STAFF REPORT

CASE NUMBER: P. D. 09-302 CC **L.U.C.B. MEETING:** July 9, 2009
Held from May 14, 2009

DEVELOPMENT: CORDOVA RIDGE PLANNED DEVELOPMENT, 4TH Amendment

REQUEST: Plan amendment to create Parcel 1-B to allow self-service mini-storage warehouses in Parcel 1 of the Outline Plan.

OUTLINE/CONCEPT PLAN:

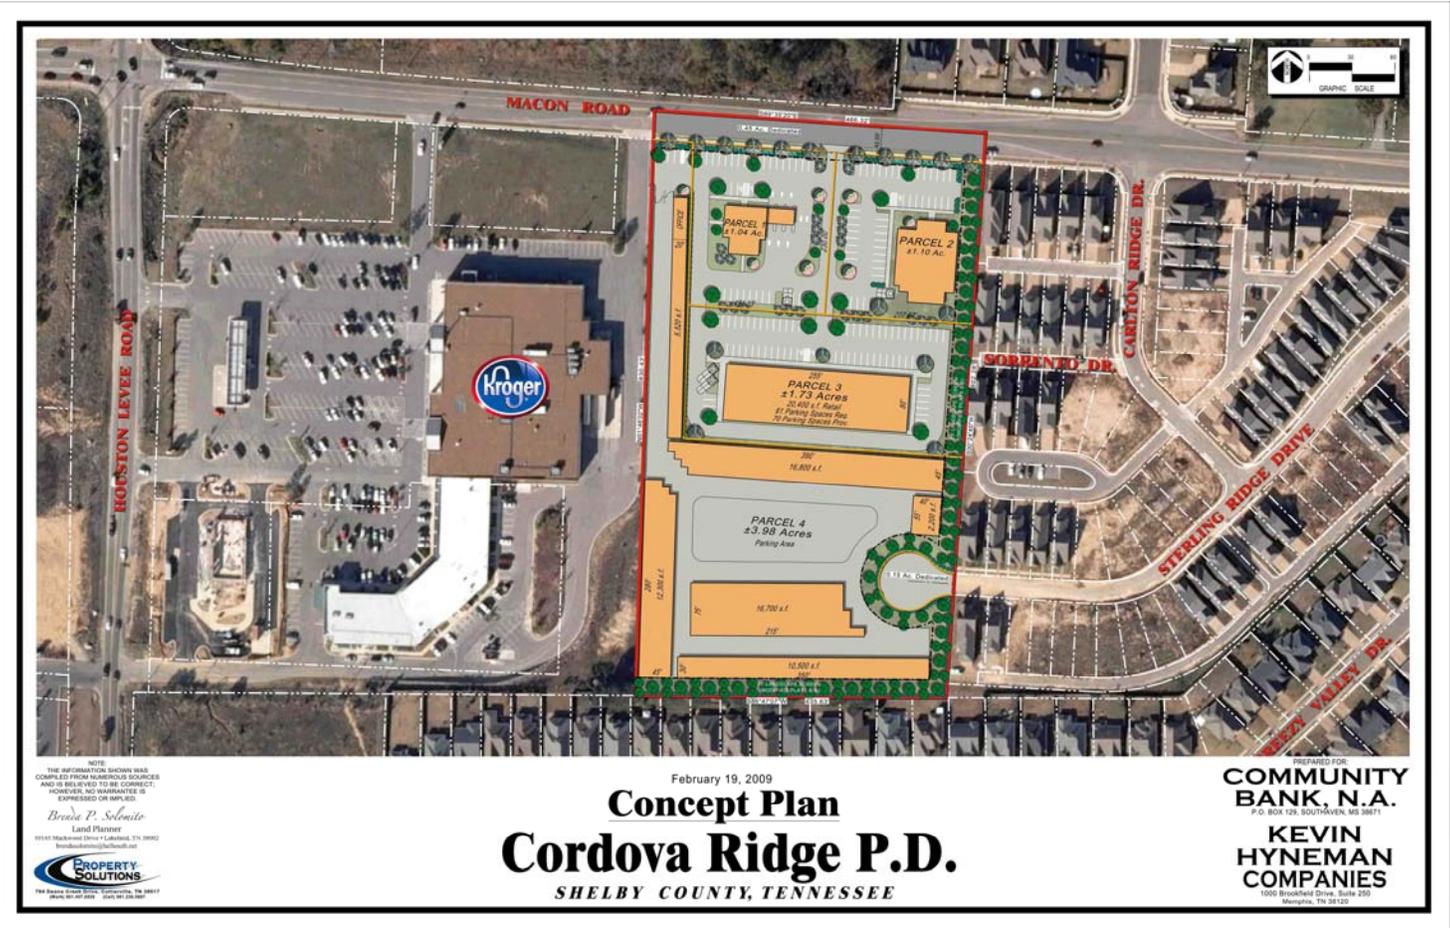
- 1. The requested amendment to Parcel 1 of the Outline Plan is to allow self-service mini-storage warehouses to be located to the rear of a large retail building in the center of the parcel, including a bank and a small retail building along Macon Road as depicted on the Concept Plan.**

- 2. This amendment proposes to create Parcel 1-B to also allow outdoor storage for recreation vehicles located to the interior of the storage buildings. The original plan approved in 1996 allowed office development in Parcel 2 as a transitional buffer zone between commercial at the major road intersection and single family residential development.**

- 3. The site meets the minimum standard for site selection for mini-storage warehouses adjacent to residential for a lot between one(1) and four(4) acres by zoning ordinance, including additional standards regarding the treatment of outdoor storage. This zoning change would be an acceptable alternative to C-P District land use if elevation plans illustrating residential-style architecture, pitch roof lines with asphalt singles and brick exterior walls are included in the Concept Plan.**

- 4. Furthermore, Sterling Ridge Drive should be considered as an extension to 'Cordova Ridge Shops' to maintain interconnectivity within this development. The total block perimeter measured from the intersection of Breezy Valley Drive and Macon Road is 6,000 feet which far exceeds the recommended maximum block length of 3,000 feet.**

- 5. The single family residential development within this plan is within walking distance of a neighborhood center. This development plan should be more compatible with residential development and provide pedestrian walkways and street connections. This amendment to allow a modification to a land use plan should incorporate recommendations of staff and the Gray's Creek Association in the Concept Plan.**

TOTAL BLOCK PERIMETER MAP:

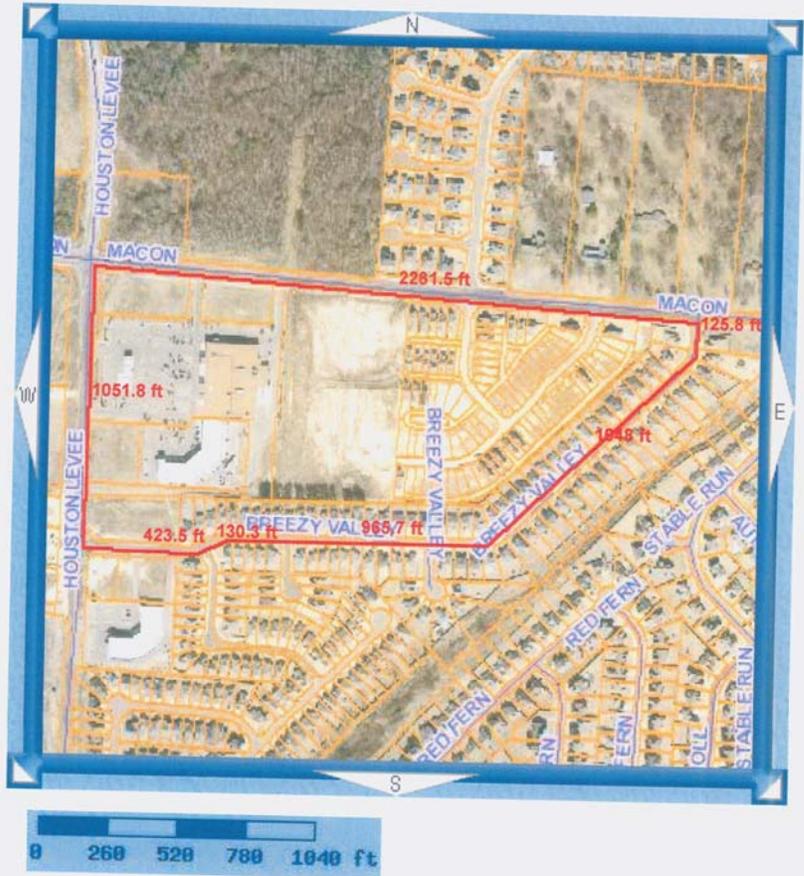
Furthermore, Sterling Ridge Drive should be considered as an extension to the ‘Cordova Ridge Shops’ to maintain interconnectivity within this development. The total block perimeter measured from the intersection of Breezy Valley Drive and Macon Road is 6,006 feet which far exceeds the recommended maximum block length of 3,000 feet. The extension of Sterling Ridge Drive through Parcel 1-A will reduce the maximum block length by one-half or 2,846 feet and allow neighborhood residents access to the commercial services without traveling on the major road, Macon Road. Because this application does not address these concerns, staff is recommending rejection of this application until possible solutions concerning the road extension and the type of architecture of the buildings within this development have been addressed and more importantly, the relationship with adjacent single family homes.

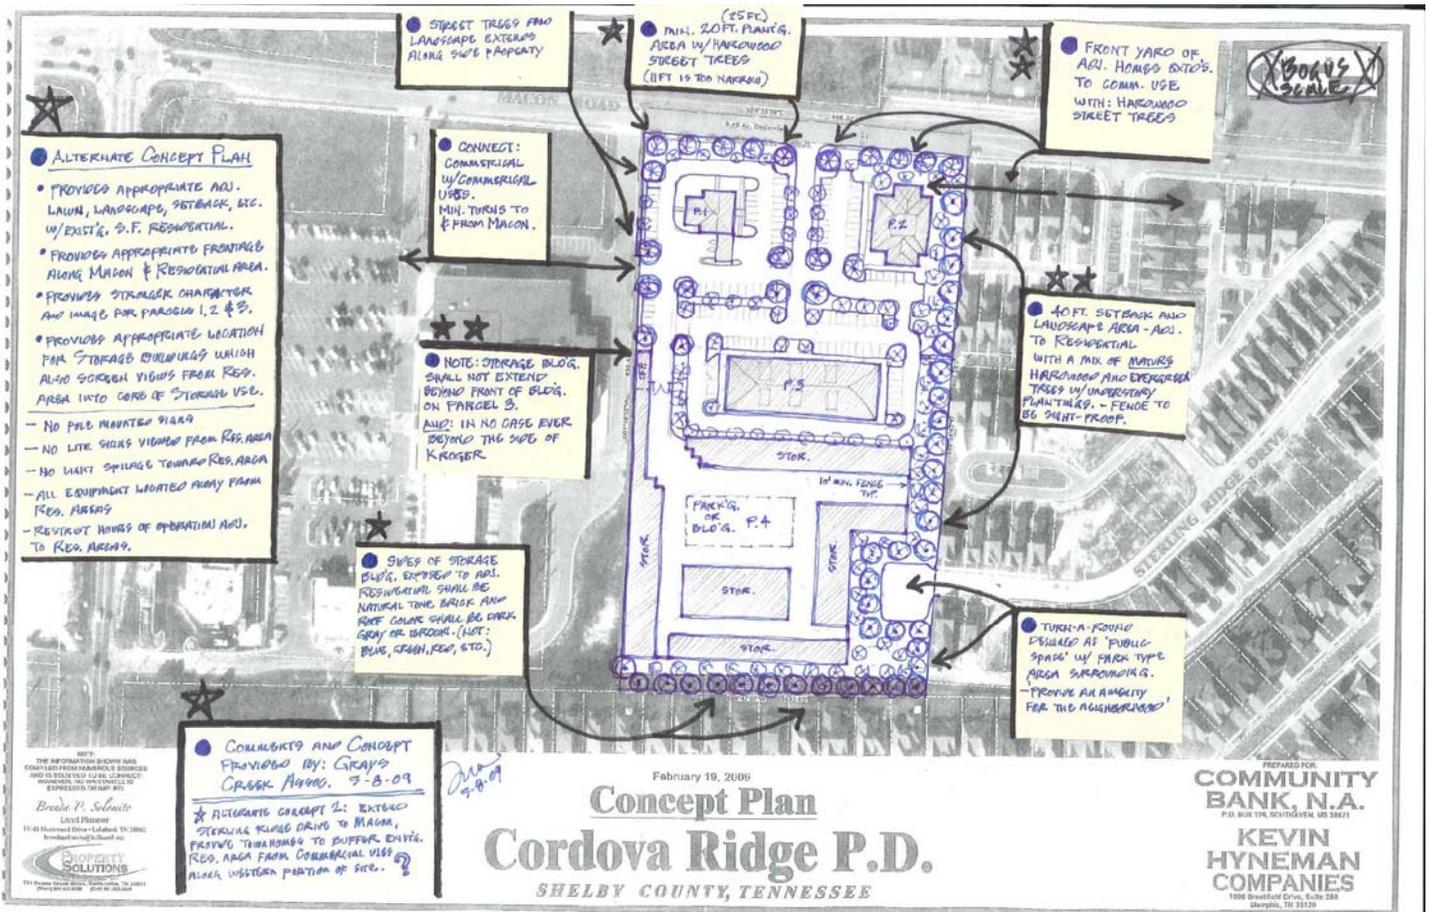
Attached are the mark-ups for the Cordova Ridge application located along Macon Rd.

The first drawing identifies the issues and the second provides one solution which addresses the issues. I had about four different concepts but once I read thru the application and figured out the original plan allows CP uses on this site it seemed like a far reach to ask them to do Residential and given that there are many vacant residential lots adjacent I don't believe this approach would gain us any traction. So with short time available I focused on showing how their basic desires could be achieved with min. changes to their plan.

The parking lot in front of parcel 2 which is adjacent to the existing residential area will create a negative situation for these homes. The revised concept plan addresses this and should be a requirement of approval.

The existing homes have min. side yard setbacks, the 40ft. setback and landscape screen I've shown is not excessive due to the difference in uses and the issues the homeowners will face. I believe I read in the orig. application that a 40ft. setback was required on another abutting residential parcel.

(1) Comment: *Open view to storage with no landscape screen (traveling east on Macon Road).*

(2) Comment: *Negative view traveling west on Macon Road.*

(3) Comment: *Site Plan locates commercial use parking lot adjacent to residential homes and yards.*

(4) Comment: *25-foot landscaping screen (along east line of parcel) is not adequate for such conflicting uses. Suggest a 40-foot screen.*

(5) Comment: *No connection commercial use to commercial use. Burdens Macon Road.*

(6) Comment: *Minimum 20-foot wide planting area for street scape along Macon Road. 11-feet is too narrow to sustain hardwood street trees.*

(7) Comment: *Extend the front yard setback dimension of the adjacent residential homes into Parcel 2 as a landscape area and plant with hardwoods.*

(8) Comment: *Outdoor R.V. parking area is exposed to residential street creating a negative view.*

(9) Comment: *Why cul-de-sac if street was designed to connect? Obvious intent was to connect Sterling Ridge Drive.*

- (10) Comment: *Storage buildings shall not extend (northward) beyond front of building on parcel 3 and in no case ever beyond the side of Kroger.*

- (11) Comment: *Does not add value to the area. Creates negative value to adjacent residential single family homes and surrounding area.*

Response: First, the concept plan is sensitive to the surrounding area by using a very narrow entrance on Macon Road. The entry is only 55 feet wide when most mini-warehouse developments use 100 feet or more.

Response: Again, the proposed architecture for the mini-warehouse building elevations will be all masonry so the view while traveling west on Macon will effectively be a brick wall with an eight-foot evergreen screen in front. This would not create a negative view looking west into the site.

Response: Parcels 1, 2, and 3 are not a part of this application and are shown on the concept plan for illustrative purposes only. Parcel 4 is the only portion of the property for which the additional mini-warehouse use is being added. The balance of the property (Parcels 1, 2, and 3) will remain as previously approved. It should be noted that the 25-foot landscape screen (with sight proof fence) shown along the east boundary of Parcels 2 and 3 is 10-feet wider than the 15-foot screen required by the approved planned development and meets the specifically referenced landscape requirement in ZTA 96-002CC.

Response: See response to Comment (3). The applicant is opposed to a 40-foot landscape screen along the east line.

Response: The concept plan absolutely does connect the subject parcel with the commercial parcel adjacent to the west (Kroger). The existing drive located on Macon at Kroger's east line will be shared with and provide access to the site.

Response: Standard plate A-3 is required by the approved P.D. and has been the typical requirement for many years. The applicant is opposed to the placement of arbitrary requirements or conditions on its property.

Response: The applicant is opposed to this 'taking' of its property.

Response: The fully developed cul-de-sac shown on the concept plan is superior to the undersized patch of asphalt that currently exists. The residents currently have a view of the rear of the Kroger store.

The concept plan proposes the planting of a 25-foot wide landscape screen completely around the head of the cove. The screen will include a sight proof fence. This plan represents a dramatic improvement of the existing condition.

Response: The adjacent neighborhood (Cordova Ridge P.D. Phase 7) is only 11.2 acres in size and was originally designated for office uses. When it became apparent that the demand for office along this portion of the Macon corridor was low the County allowed this property to be rezoned for residential uses. Please note that this subdivision has no connectivity to any of the surrounding neighborhoods and has two points of access to Macon Road.

Response: This condition is unacceptable because it provides no presence along Macon Road for the mini-warehouse site. Additionally, the alternate site configuration presented is not practical because it does not allow for ingress and egress of moving vehicles into and out of the storage facility without driving through parking lots designated for service to the retail component of the development. The alternate site plan does not appear to provide proper turning radii to accommodate typical moving vehicles.

Response: This comment seems short sighted. If this commercial parcel is allowed to develop as submitted with appropriately designed architectural elements it will enhance rather than detract from the overall neighborhood.
